UNITED STATES
DEPARTMENT OF THE INTERIOR
BUREAU OF LAND MANAGEMENT

SUNDRY NOTICES AND REPORTS ON WELLS
Do not use this form for proposals to drill or to re-enter an abandoned well. Use form 3160-3 (APD) for such proposals.

Cimarex respectfully requests approval to plugback the Oracle 21 Federal 1 well to the Atoka as indicated below:

Cimarex Energy Company
Oracle 21 Federal - 01
API 3001535110, T25S-R26E, Sec 21
August 28, 2014

Cimarex Energy Co. of Colorado
Oracle 21 Federal #1
660' FNL & 660' FWL
Sec. 21, T-25-S, R-26-E, Eddy Co., NM
S. Gengler 02/15/2010

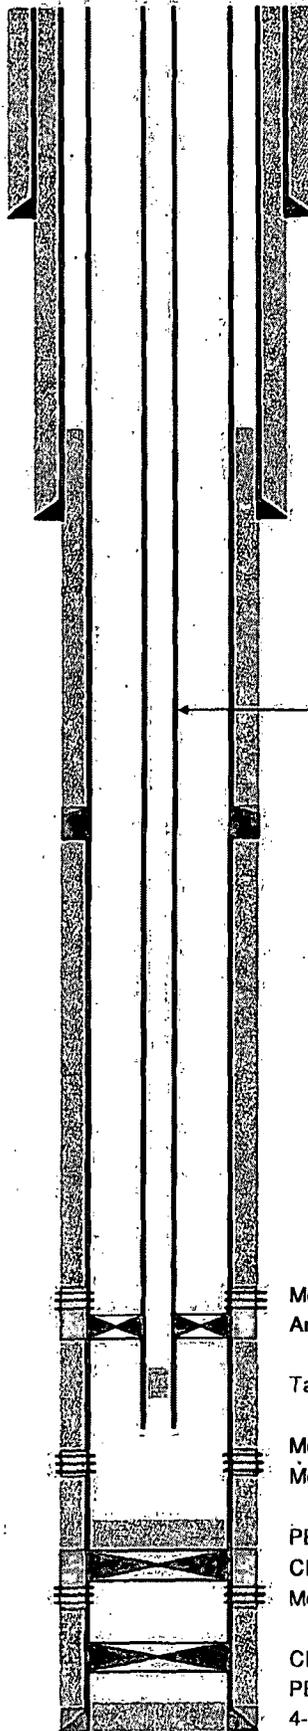
10. **Step 2. - tag (verify) the CBP setting depth of 11590 prior to setting the CIBP within 100' of the top Morrow perforation.**
11. **This procedure is subject to the statements numbered 11 through 13.**

14. Minimum requirement for mud placed between plugs is 25 sacks of salt water gel per 100 barrels in 9 lb/gal brine.
15. **Tag the Class H cement plug of Step 2 (minimum WOC of 8hrs) with tubing at 11150 or above.**
